DOCUMENT 00 90 00
ADDENDUM

ADDENDUM NO. [1] **Date: March 22, 2018**

RE: WESTERN TECHNICAL COLLEGE
ARC LIBRARY REMODELING & VETERAN'S CENTER ADDITION
400 SEVENTH STREET NORTH
LA CROSSE, WISCONSIN 54601
HSR PROJECT NO. 17026

A002R

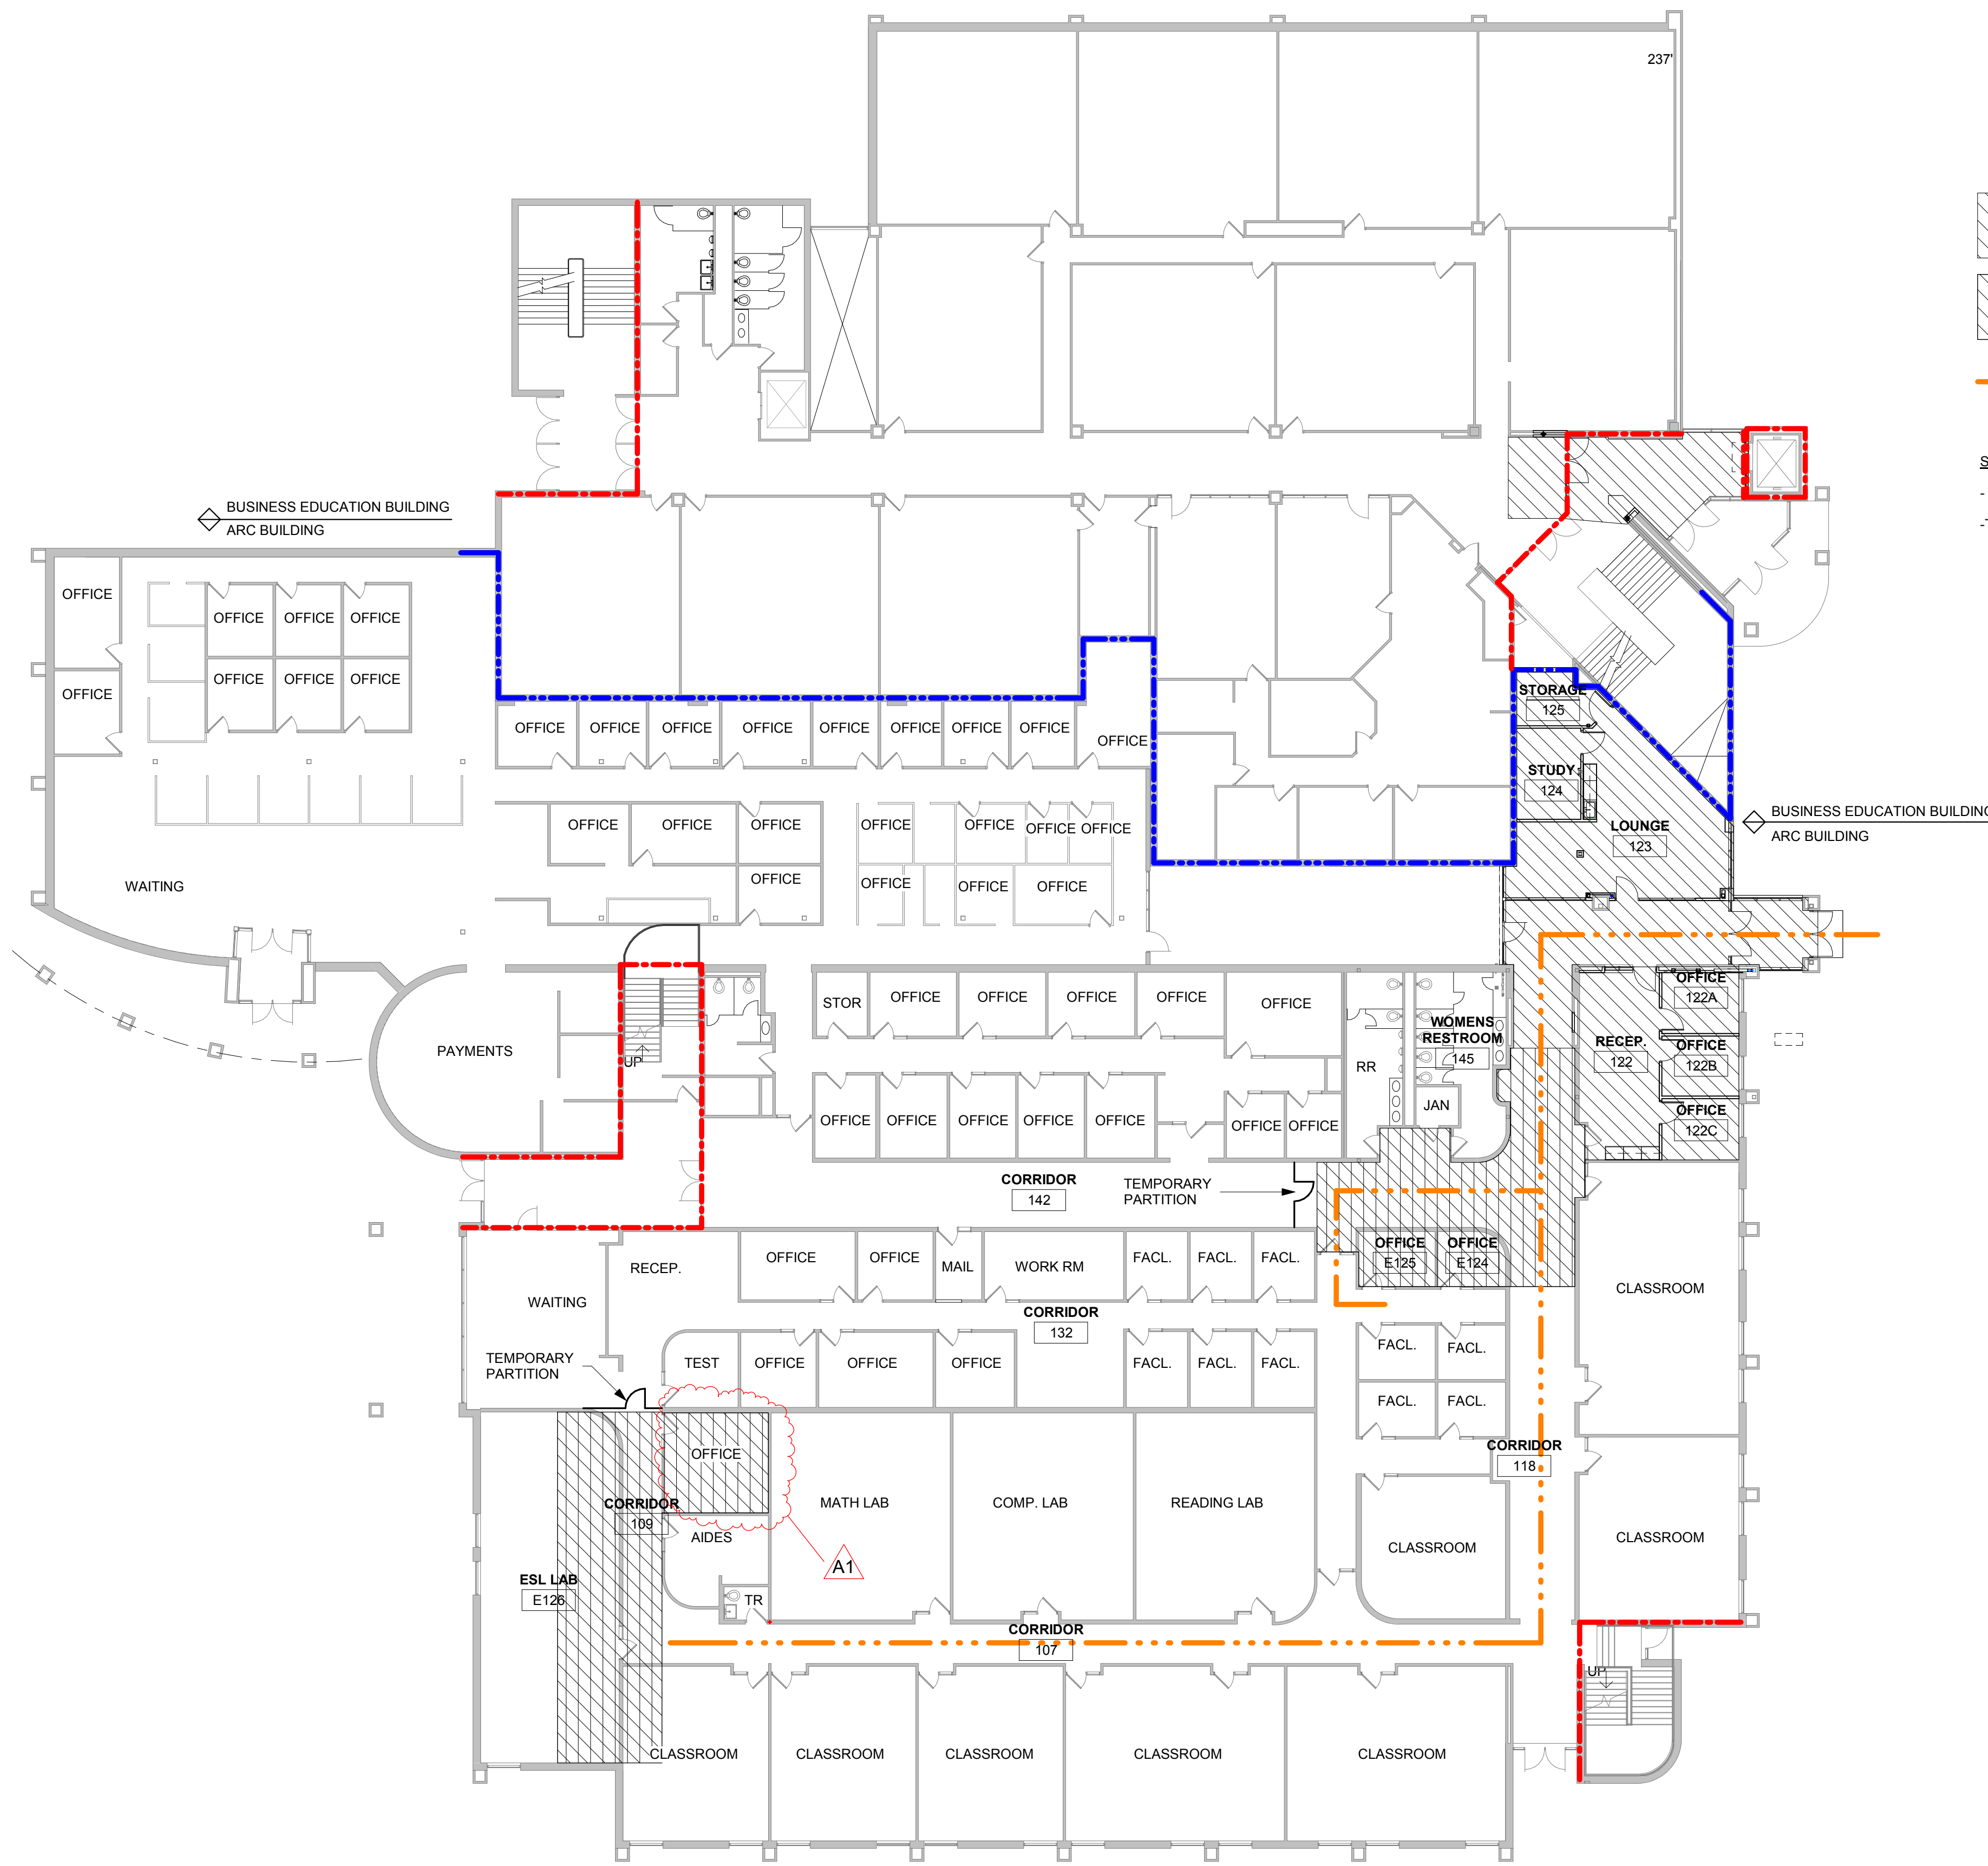
10. Sheet A002R OVERALL FLOOR PLANS 30 x 42 attached hereto
 - a. Revisions clouded on Drawing.
11. Sheet A091 LIBRARY REMOVAL
 - a. AT RM E209 remove casework from south wall.
12. Sheet A100R FIRST FLOOR REMODELED 30 x 42 attached hereto
 - a. Revisions clouded on Drawing.
13. Sheet A102R LIBRARY RCP PLAN 30 x 42 attached hereto
 - a. Revisions clouded on Drawing.
14. Sheet A200R EXTERIOR AND CASEWORK ELEVATIONS 30 x 42 attached hereto
 - a. Revisions clouded on Drawing.
15. Sheet A600R DOOR SCHEDULE AND WALL TYPES 30 x 42 attached hereto
 - a. Revisions clouded on Drawing.
16. Sheet ID101R FINISH FLOOR PLAN 30 x 42 attached hereto
 - a. Revisions clouded on Drawing.
17. Sheet FP100 FIRE PROTECTION
 - a. Remove scope of work for revising the existing fire sprinkler system near rooms Corridor 100 and Vestibule 101.
